ACCESSION NBR: 9503010391 DOC. DATE: 95/02/20 NOTARIZED: NO DOCKET #
 FACIL: 50-250 Turkey Point Plant, Unit 3, Florida Power and Light C 05000250
 AUTH. NAME AUTHOR AFFILIATION
 PLUNKETT, T.F. Florida Power & Light Co.
 RECIP. NAME RECIPIENT AFFILIATION
 Document Control Branch (Document Control Desk)

SUBJECT: Forwards relief request for Turkey Point Unit 3 Class 1 & Class 2 pressure retaining similar & dissimilar metal welds in vessels & piping.

Re: Turkey Point Unit 3
Docket Nos. 50-250
Impractical Inservice Inspection
Requirements - Second Ten Year
Interval Program Summary Report

Relief Request No. 1

FIGURE 15

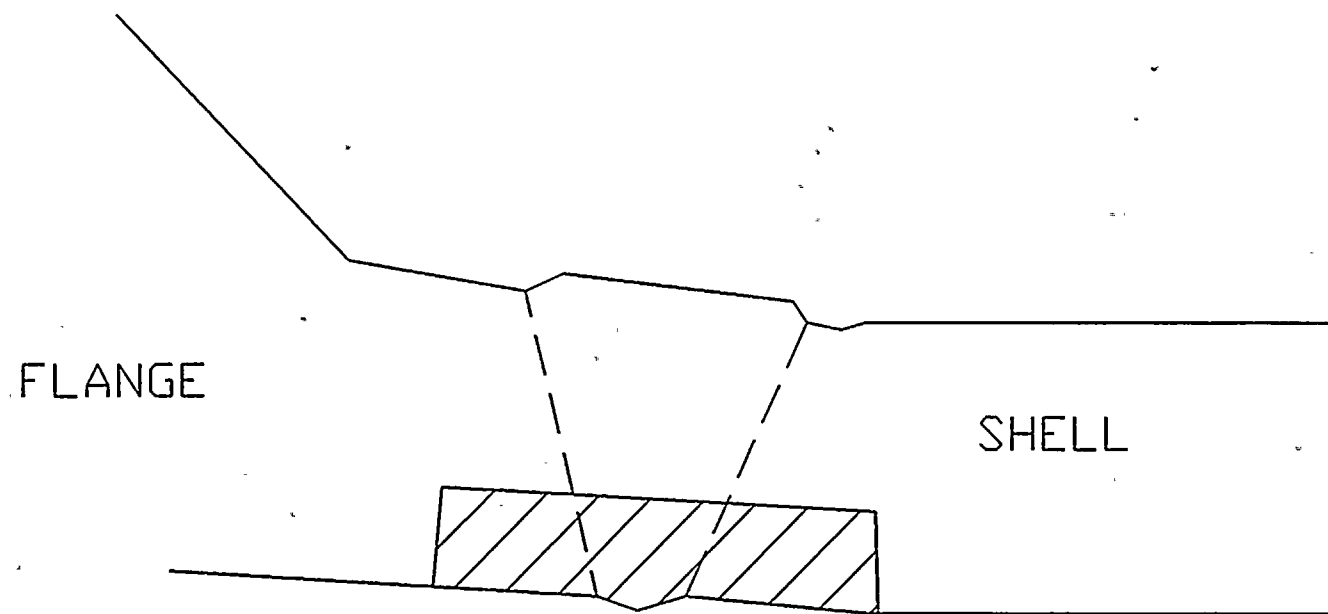
Catgy/ Item No.	Year of Exam	Zone	Item	NDE Tech	Angle and Technique			Configuration or Limitations	Fig. No.	Comments / % Coverage
					1/2 V	Full V	1 1/2 V			
B-J B9.11	90	3-012	27.5"-RCS-1306-11	UT	45	-	-	Pump casing to pipe	14	100% from Pipe Side, 0% from Pump Side
B-J B9.11	90	3-016	12"-RC-1301-1	UT	45 60	- -	- -	Branch connection to pipe	15	100% from Pipe side, 0% from Nozzle side
B-F B5.40	90	3-017	4"-RC-1301-1A	UT	45	-	-	Nozzle to safe-end	23	50% from Safe End Side, 50% from Nozzle Side
B-F B5.40	90	3-022	4"-RC-1306-1A	UT	45	-	-	Nozzle to safe-end	23	50% from Safe End Side, 50% from Nozzle Side
B-J B9.11	90	3-036	14"-RHR-1301-6	UT	45 60	- -	- -	Pipe to valve 3-750	15	100% from Pipe Side, 0% from Valve
B-J B9.11	90	3-037	8"-RHR-1301-3	UT	45 60	- -	- -	Elbow to valve 3- 876A	24	100% from Elbow side, 0% from Valve side
B-J B9.11	90	3-038	10"-SI-1302-1	UT	45 60	- -	- -	Elbow to branch connection	15	100% from Elbow Side, 0% from Branch Side

B-J B9.11	90	3-038	8"-RHR-1302-1	UT	45 60	- -	- -	Valve 3-876B to pipe	15	100% from Pipe Side, 0% from Valve Side
B-J B9.11	90	3-039	10"-SI-1303-11	UT	45 60	- -	- -	Elbow to valve 3- 875C	8	100% from Elbow side, 0% from Valve side
C-F C5.21	90	3-079	10"-SI-2302-5	UT	45 60	- -	- -	Valve 3-865B to pipe	15	100% from pipe, 0% from valve, examination not required during third interval
C-F C5.21	90	3-079	10"-SI-2302-6	UT	45 60	- -	- -	Pipe to valve 3-875E	15	100% from pipe, 0% from valve, examination not required during third interval
C-F C5.21	90	3-081	10"-SI-2305-3	UT	45 60	- -	- -	Valve MOV-3-744B to pipe	15	100% from pipe, 0% from valve

Catgy/ Item No.	Year of Exam	Zone	Item	NDE Tech	Angle and Technique			Configuration or Limitations	Fig. No.	Comments / % Coverage
					1/2 V	Full V	1 1/2 V			
C-F C5.21	90	3-081	10"-SI-2305-8	UT	45 60	- -	- -	Elbow to valve 3-885	15	100% from elbow side, 0% from valve side
C-F C5.21	90	3-081	10"-SI-2304-2	UT	45 60	- -	- -	Elbow to valve MOV-3-744A	15	100% from elbow side, 0% from valve side
C-F C5.21	90	3-081	10"-SI-2304-3	UT	45 60	- -	- -	Valve MOV-3-744A to pipe	15	100% from pipe side, 0% from valve side
C-F C5.21	90	3-085	8"-SI-2303-1	UT	45 60	- -	- -	Reducer to pipe	9	100% from pipe side, 0% from reducer side
C-F C5.21	90	3-104	6"-BDB-2302-1	UT	- 60	- -	45 -	Reducer to valve SGB-3-003	17	75% from reducer side, 70% from valve side
C-F C5.11	90	3-113	6"-FWB-2302-3	MT	-	-	-	Valve 3-20-231 to pipe, double acting restraint limits access	21	50% surface coverage examined one direction only parallel to weld, for axial flaws only

FIGURE 16

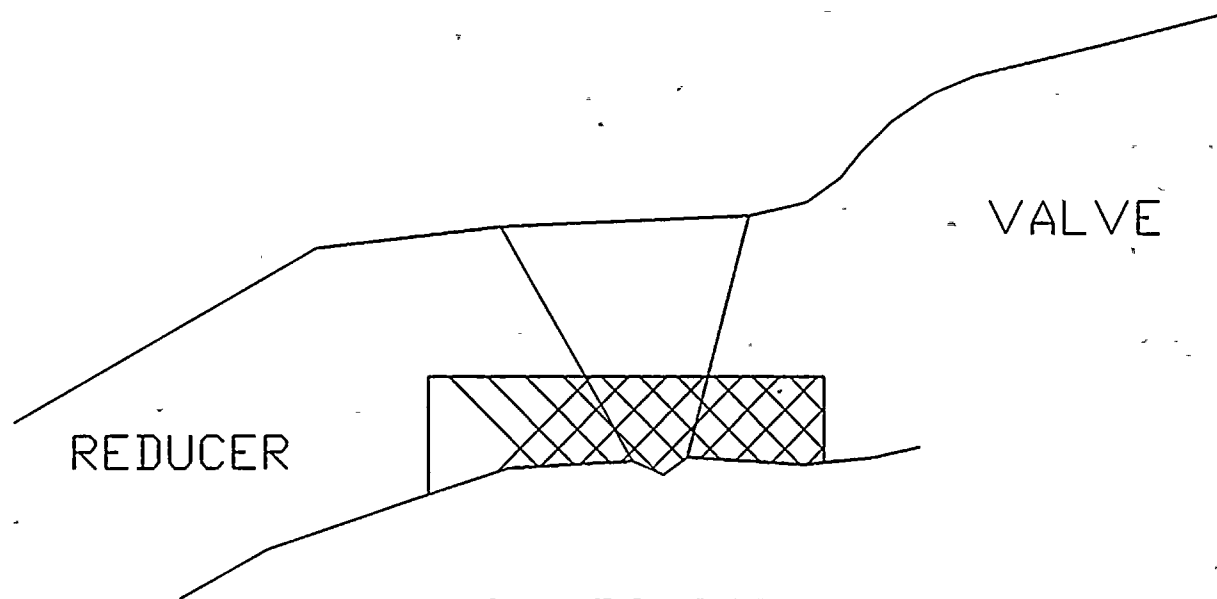
C-A C1.10	92	3-115	3-RHE-A2 ,	UT	45 60	- -	- -	Shell to Flange configuration, Branch Connections and Welded Support Pads limit exam	16	82% from Shell Side, 0% From Flange Side
B-D B3.140	92	3-005	3-SGC-I-IRS	UT	45	-	-	Welded on pads, support, and configuration	11	70% Coverage in 2 Directions
B-D B3.140	92	3-005	3-SGC-O-IRS	UT	45	-	-	Welded on pads, support, and configuration	11	70% Coverage in 2 Directions
